SUBJECT: HOMESTAKE MINING COMPANY OF CALIFORNIA, U.S. NUCLEAR
REGULATORY COMMISSION REQUEST FOR ADDITIONAL INFORMATION,
REVISED REQUEST FOR AMENDMENT TO CHANGE THE BACKGROUND
MONITORING LOCATION FOR RADON AND AMBIENT GAMMA RADIATION,
LICENSE NO. SUA-1471, DOCKET 040-08903

**U.S. Nuclear Regulatory Commission Request for Additional Information
Homestake Mining Company of California, Revised Request for Amendment to
Change the Background Monitoring Location for Radon and Ambient Gamma
Radiation, Grants Reclamation Project Materials License SUA-1471**

Request for Additional Information (RAI) -1

Figure 1. Surface water drainages in the vicinity of the GRP (from Figure 3.1-1 in HMC, 2012)

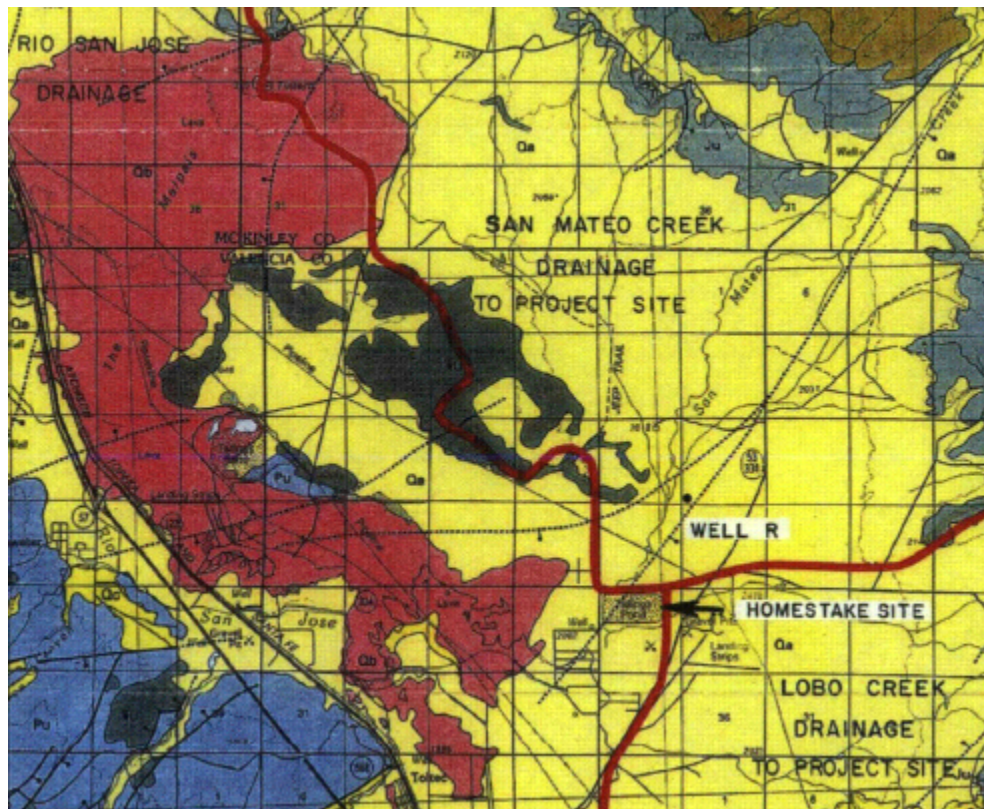
The U.S. Nuclear Regulatory Commission (NRC) staff reviewed geological (HMC, 2012) and hydrogeological (Hoffman, 2001) descriptions of the general area of the Grants Reclamation Project (GRP). Figure 1 below shows the extent of the alluvial deposits in the SMC basin as well as the SMC, Lobo Creek, and Rio San Jose surface water drainages. The report by Hoffman (2001) describes the San Mateo alluvial system as following "...the San Mateo alluvium and drainage system and extends from the northeast of the site to the south and west."

Figure 2. Alluvial plain in the vicinity of the GRP with environmental monitoring stations as described by HMC (from Figure 8 of Attachment 1 to HMC, 2020a)

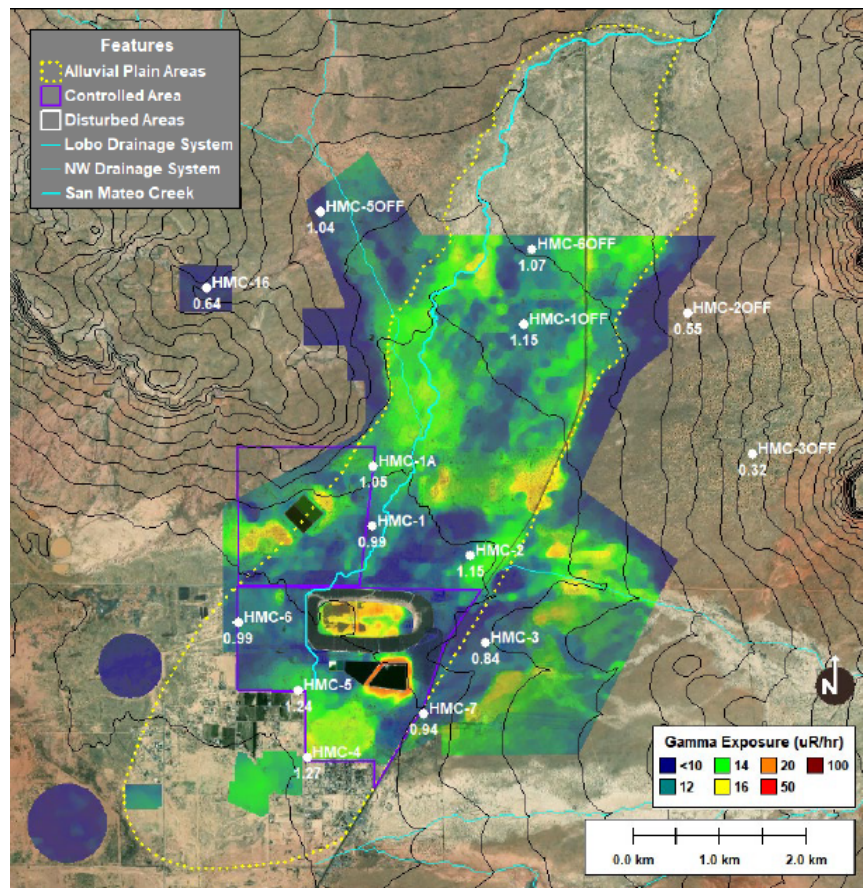
Provide a justification for confining the alluvial plain to the San Mateo Creek (SMC) alluvial plain as indicated in Figure 7 of Attachment 1 to the Homestake Mining Company of California (HMC or licensee) December 2020 submittal (HMC, 2020a).

Figure 2 (below) shows the alluvial plain as defined by HMC and used in its evaluation of proposed background radon monitoring stations.

Figure 3. NRC staff's representation of the alluvial plain with maximum elevation of 2,023 m (green outline), northeast to southwest elevation (blue line and bottom elevation profile), and east-west "flat" areas (i.e., relatively small elevation changes) (red lines).

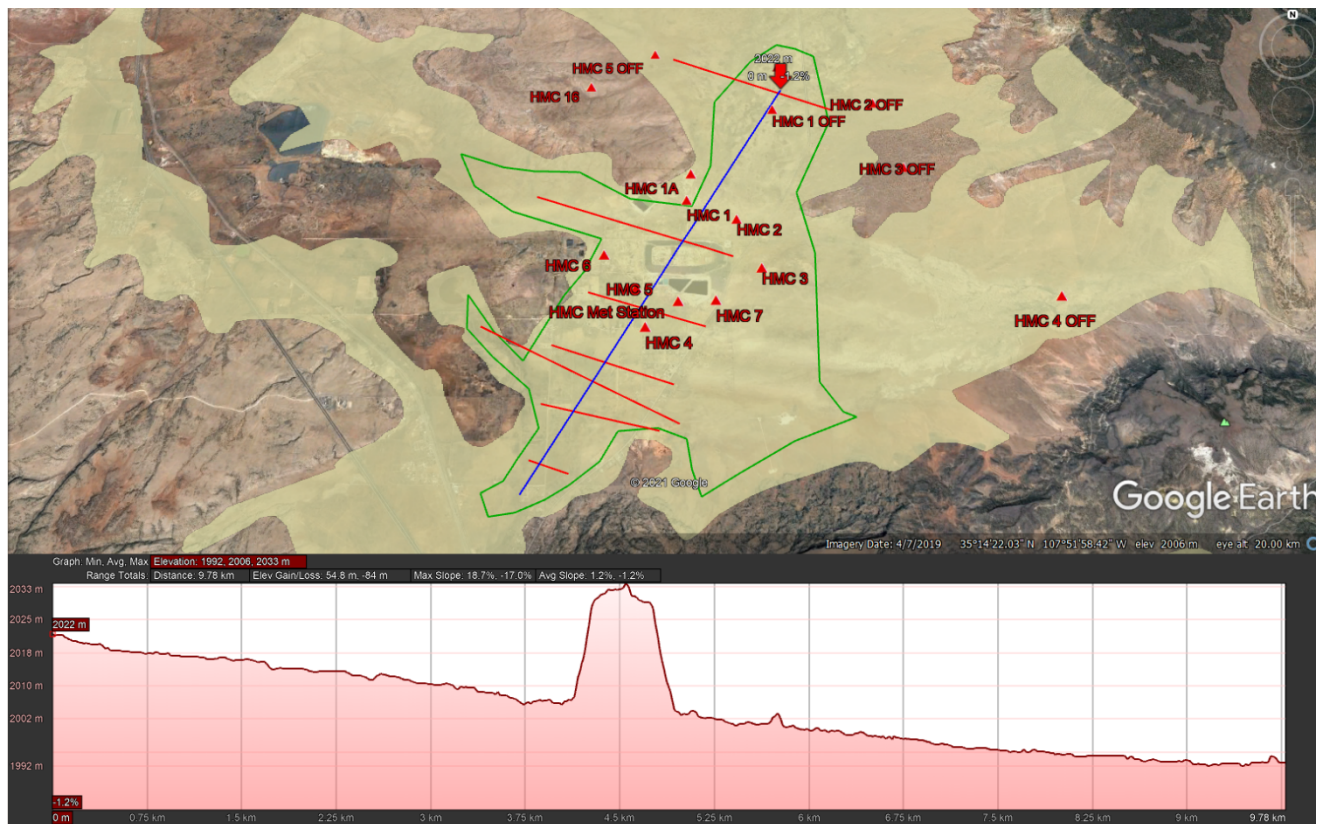
Using data from the United States Geological Survey (USGS, 2021a), the NRC staff evaluated the geology and topography in the vicinity of the GRP using Google Earth Pro. The green outline area in Figure 3 below represents the NRC staff's interpretation of a broader alluvial plain based on reported alluvium deposits (yellow shaded area) in the vicinity of the GRP. For comparison purposes, the maximum elevation around the perimeter is approximately 2,023 meters (m) (6,637 ft) to coincide with HMC's proposed HMC-6OFF location.

The NRC staff notes that the northeast to southwest line through the San Mateo drainage (the blue line in Figure 3) continues decreasing in elevation. The elevation change between HMC-6OFF and the current monitoring station HMC-4 is approximately 23 m (75 ft) [21m (69 ft) for HMC-1OFF]. HMC-6OFF is approximately 6.5 kilometers (km) [4 miles (mi)] from HMC-4. HMC-1OFF is approximately 5 km (3.1 mi) from HMC-4. As indicated in Figure 3, the elevation begins to flatten out around HMC-4 and decreases approximately another 8 m (26 ft) between HMC-4 and the southwestern end of the blue line in Figure 3.

As indicated in Figure 3, HMC-1OFF and HMC-6OFF are generally closer to the upland areas of the San Mateo alluvial plain than HMC-4 and HMC-5. According to HMC (2020a), this area is a source of radon contributing to higher radon concentrations on the alluvial plain floor. However, the NRC staff considered the greater alluvial plain area in the vicinity of HMC-4 and HMC-5 (i.e., a greater area over which the pooled radon can dissipate), and that HMC-4 and HMC-5 are located further from these upland sources (see Figure 3). Taking into account the lower elevation of HMC-4 and HMC-5 relative to HMC-1OFF and HMC-6OFF, as discussed above, it is not clear to the NRC staff that HMC-1OFF and HMC-6OFF are representative of these current monitoring locations.

Figure 4. Legacy uranium mines in the vicinity of the GRP.

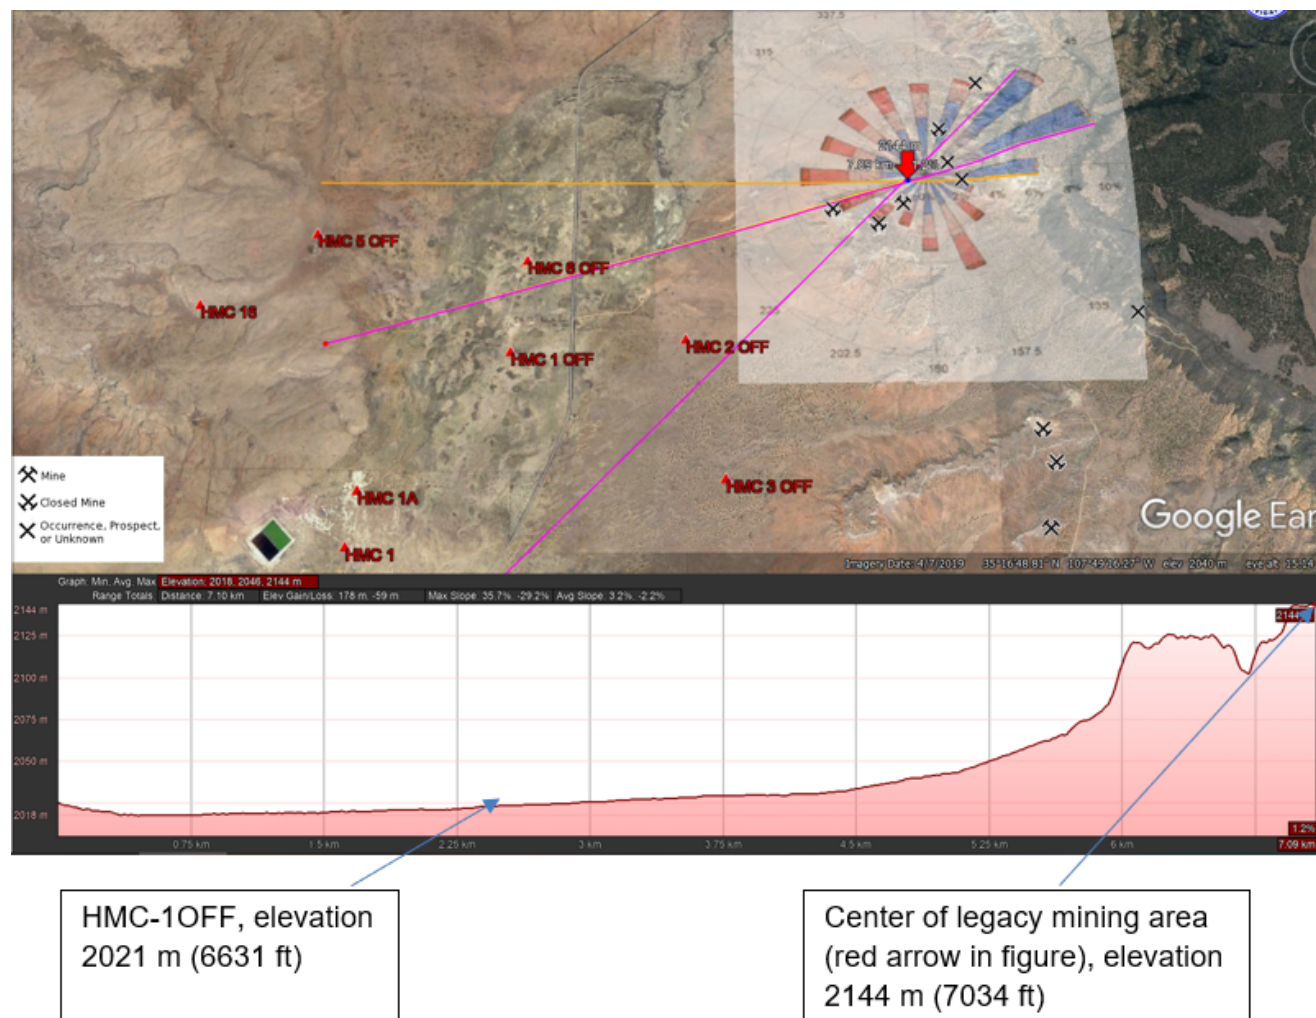
From Figure 4, HMC-1OFF appears to be downgradient from the two sectors (the purple lines in the figure) representing the largest percentage of drainage flow conditions as identified by HMC (i.e., more stable wind conditions). Adding the third highest sector (the orange line in the figure) also encompasses HMC-6OFF. It does not appear to the NRC staff that these sources were specifically evaluated previously by other authors or currently by HMC.

Figure 5. Predicted concentration normalized to HMC-16 for the case of enhanced radon flux in San Mateo Wash and based on 2017 Met data (from Figure 15 in Attachment 2 to HMC, 2020a)

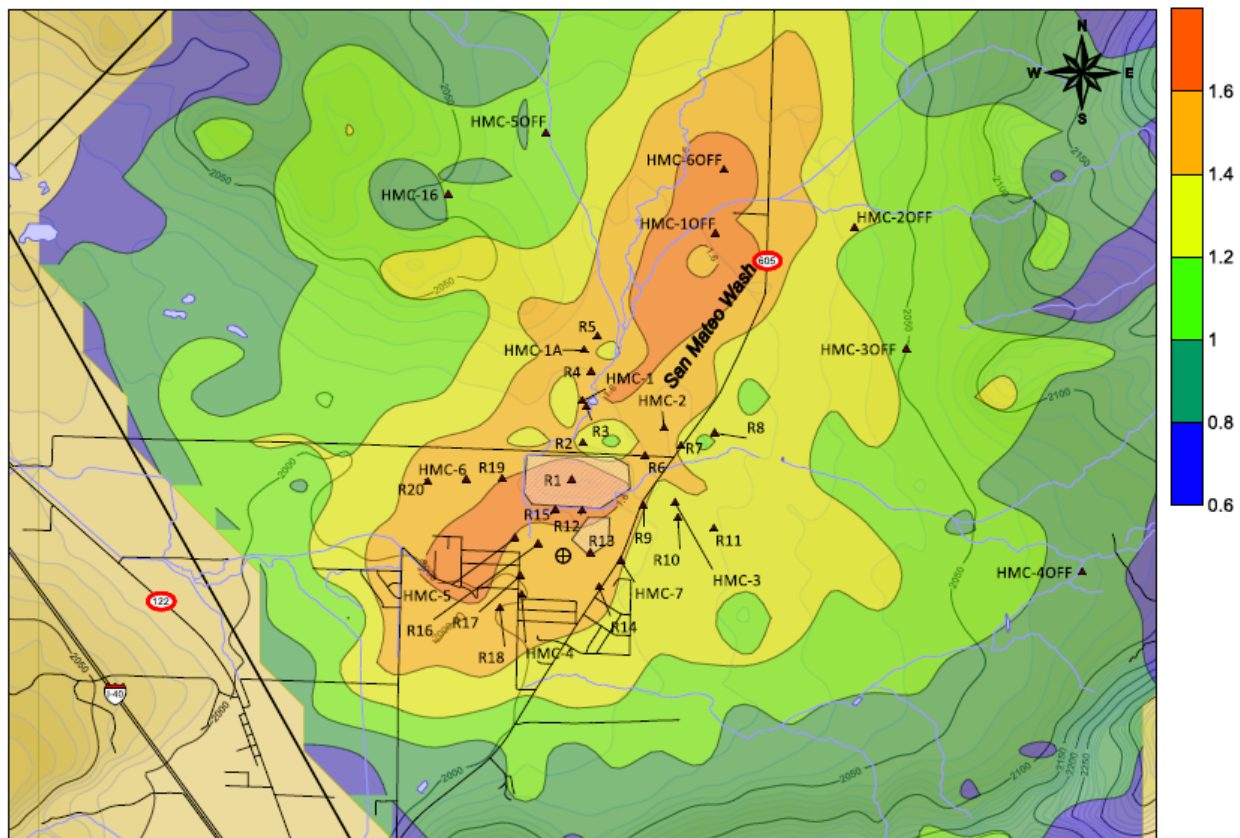
In addition, the NRC staff evaluated Figure 5 and notes that HMC-1OFF and HMC-6OFF are modeled as higher predicted radon concentrations relative to HMC-4 and HMC-5. The NRC staff recognizes that the main purpose of the figure was to demonstrate differences between radon concentrations on the upland slopes and the floor of the alluvial plain. However, any proposed background stations that are modeled as having higher background radon concentrations than the point(s) of compliance for public dose assessment (i.e., HMC-4 and HMC-5) should be cause for reexamining the CSM and evaluating any changes to the CSM, or additional data collection needs, or both.

HMC recognized the importance of this type of normalized data analysis in its response to a previous NRC staff Request for Additional Information (RAI) (see HMC response to RAI No. #2b in HMC, 2014). Furthermore, the modeling results in Figure 5 incorporate some, but not all, of the factors influencing radon concentrations at HMC-1OFF as discussed by HMC (see HMC response to RAI No. #9b in Attachment 3 to HMC, 2020a). For example, Figure 5 does not include an estimated effect of known localized radon sources that could potentially increase the differences between HMC-1OFF and other monitoring stations.

Figure 6. Soil type north of the GRP LTP (USDA, 2021)

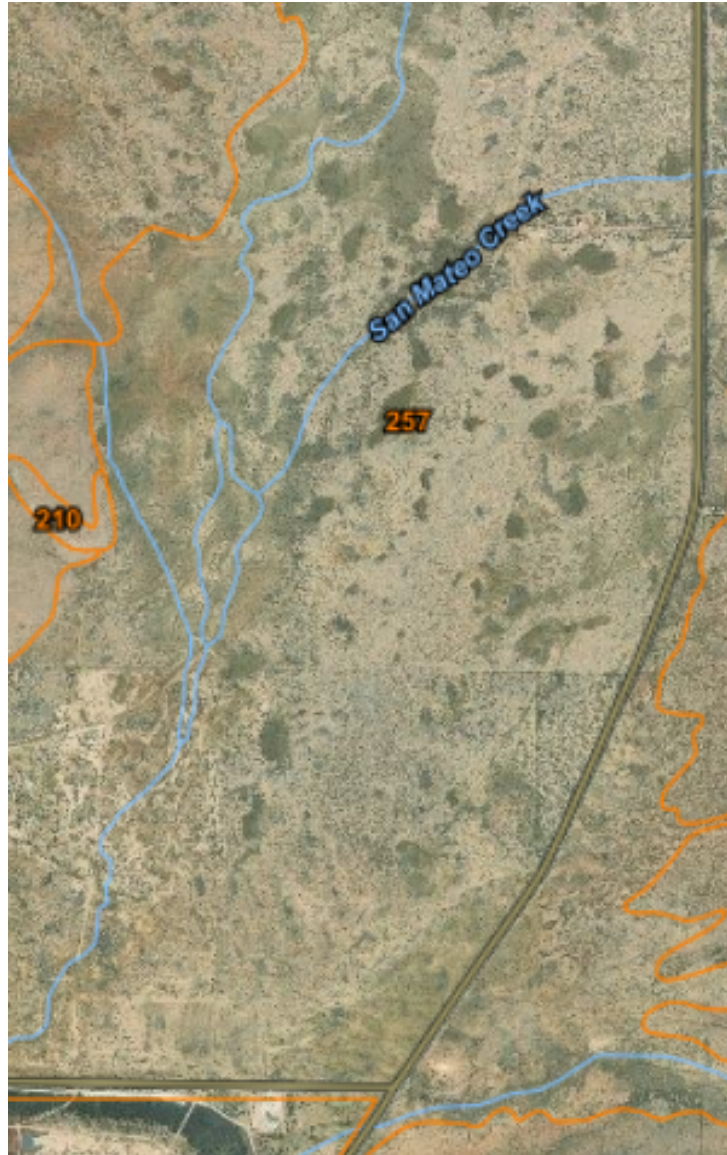
The NRC staff utilized the online Web Soil Survey (U.S. Department of Agriculture [USDA], 2021) to visualize the soil types in the vicinity of the GRP. As Figures 6 and 7 show, there is basically one soil type in the relevant area north of the large tailings pile (LTP) (Type 257) where the proposed HMC-1OFF and HMC-6OFF are located. South of the LTP, including HMC-4 and HMC-5, there are a variety of different soil types. These soil types may be very similar in their ability to impact the exhalation of radon gas from the soil surface; however, considering the importance of local soils in HMC’s stated CSM, and the fact that the proposed background locations reside in soil types different from the locations of public dose compliance (i.e., HMC-4 and HMC-5), HMC should analyze any differences and potential impacts to the CSM.
